Re: Bowdens Silver Project (SSD 5765) – Traffic-related Request for Information

The following provides a response to matters raised in a request for information provided to Bowdens Silver by the Department of Planning and Environment in relation to the Bowdens Silver Project (the Project). The queries provided to Bowdens Silver are presented in italics with a response following each query.

Figure 2.16 LOCAL ROAD NETWORK

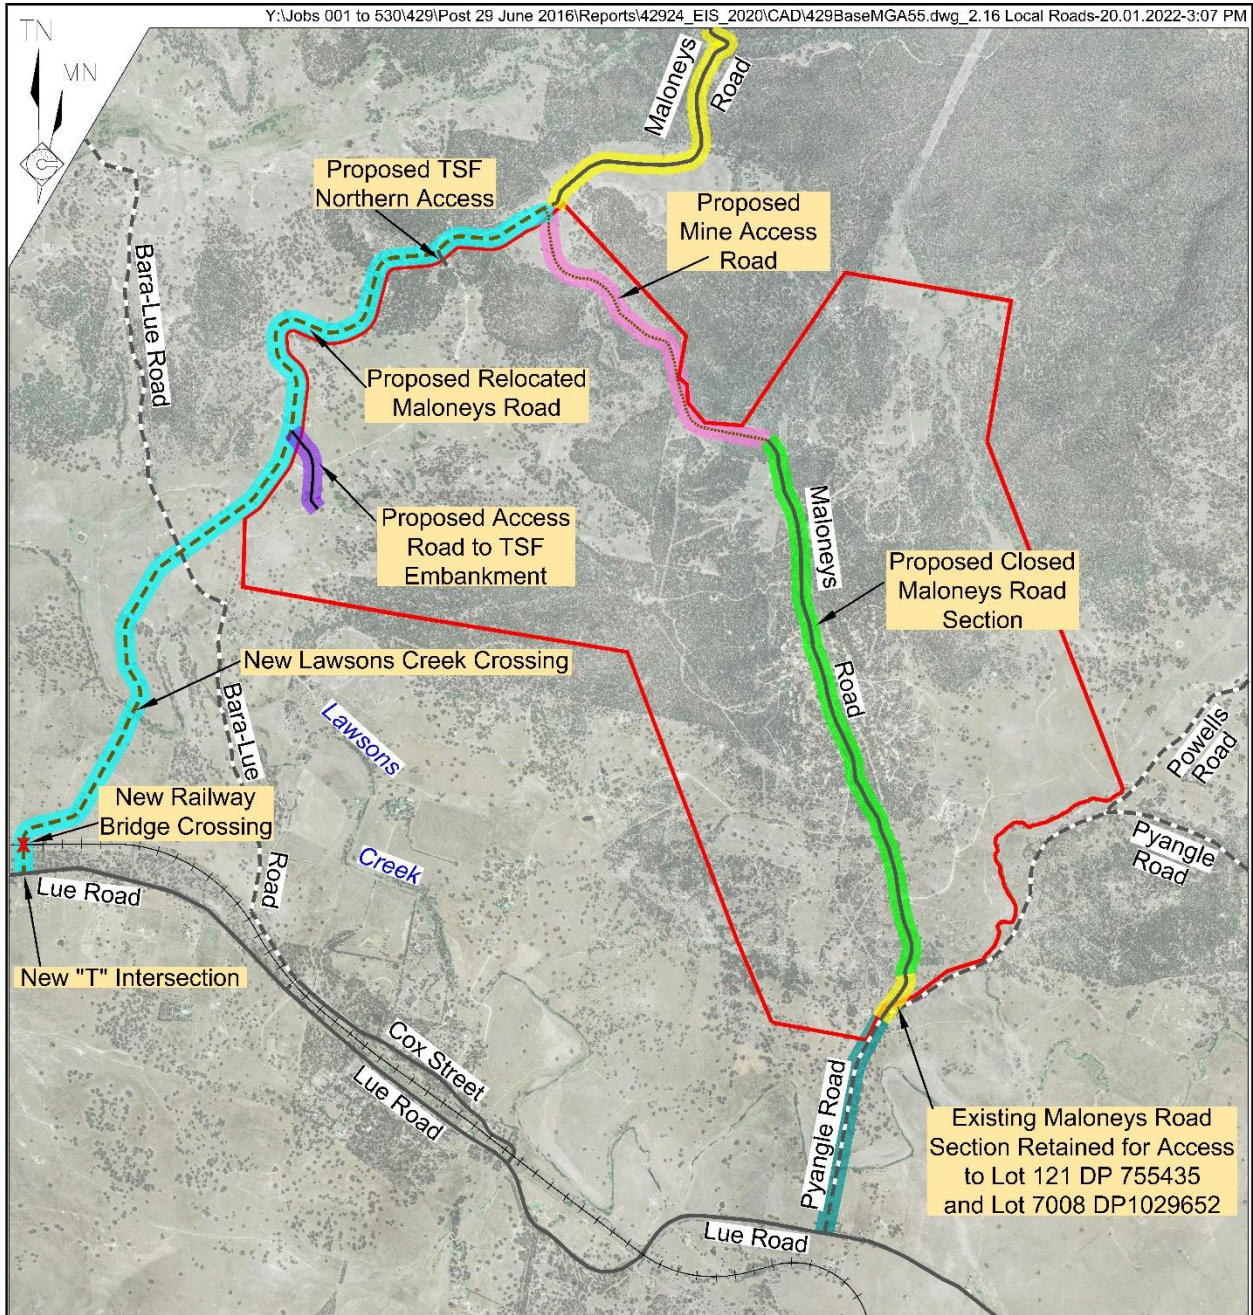
Heavy vehicle traffic along the relocated Maloneys Road, particularly the haulage route between the mine site access road and the TSF, would be significant at all times, but in particular during peak construction it appears that there would be an average of one project vehicle every 1 - 1.5 minutes, and when the TSF lifts are under construction there would be an average of around 1 vehicle every 2-3 minutes (based on an 11 hour day). This presents a potential safety risk to other road users.

Please provide consideration of the option of retaining the existing Maloneys Road as a public road and designating the relocated Maloneys Road as a private road., and/or consideration of using an alternative haulage route within the mine site (possibly directly over the area of the TSF) rather than using the relocated Maloneys Road.

While the change in traffic levels across the entire length of the relocated Maloneys Road may be considered significant when compared to the current use of Bara-Lue Road and the existing Maloneys Road, the total traffic generation is not significant and would be mitigated principally by constructing the road to suit the intended use. The traffic generation for haulage of NAF waste rock to be used in constructing the TSF represents a significant increase in traffic but would only occur along a 1.4km section of the relocated Maloneys Road.

Table A presents a summary and analysis of the average weekday traffic at these locations and the predicted traffic levels during the peak construction period. **Figure A** is a reproduction of Figure 2.16 from the EIS that presents the local road network in the vicinity of the Mine Site.

If the 58 movements per day required by other heavy vehicles during months 7 to 18 of site establishment and construction (see **Table A**) are added to the analysis, the peak hourly movements increase to 29/30 and there may be a Project-related vehicle approximately every two minutes. However, beyond the 1.4km section between the Mine Site access and the TSF, heavy vehicles would be encountered only once every ten minutes. As noted above, while this represents a change to the traffic present in this location, it is not considered to be a significant road safety risk, with the relocated Maloneys Road to be designed and constructed to accommodate the predicted traffic types and levels.

Retaining public access to the existing Maloneys Road following construction of the relocated Maloneys Road would be problematic given the high-volume nature of internal mining traffic, the size of haulage vehicles and other mobile equipment and the presence of these slow moving, possibly laden vehicles. The length of road where interaction may occur is 1.4km in the currently proposed configuration and this would increase substantially if public traffic was to pass through the Mine Site. It is standard practice for mining vehicles to have UHF radios installed and use positive communication while moving around the site, which requires that vehicles hold at designated positions until positive communication is received from nearby vehicles and equipment confirming that the operator is aware of the approaching vehicle and able to maintain a safe separation distance. It would be virtually impossible to implement this safety measure for public vehicles. Retaining public access would also require that Mid-Western Regional Council ultimately retain responsibility for the maintenance of the existing Maloneys Road.

Using an alternative route to the TSF is considered impractical and an unreasonable alternative. The location of the relocated Maloneys Road has been selected to provide a reasonable grade and separation from other Mine and public structures. A road through the proposed TSF adjacent to Walkers Creek is the only feasible alternative option but would require vehicles to climb at significant grades to enter and exit the gully, generating additional noise and exhaust fumes. In addition, the alternative road would only be feasible until construction of the TSF commences. This is programmed for Month 6 with the bulk of material to be supplied from Month 7 for immediate use. An alternative approach would require storage of approximately 2 million tonnes of waste rock prior to closure of the road and commencement of TSF construction. Not only would this be practically difficult, but it would also add unreasonable cost and time delays to the construction process.
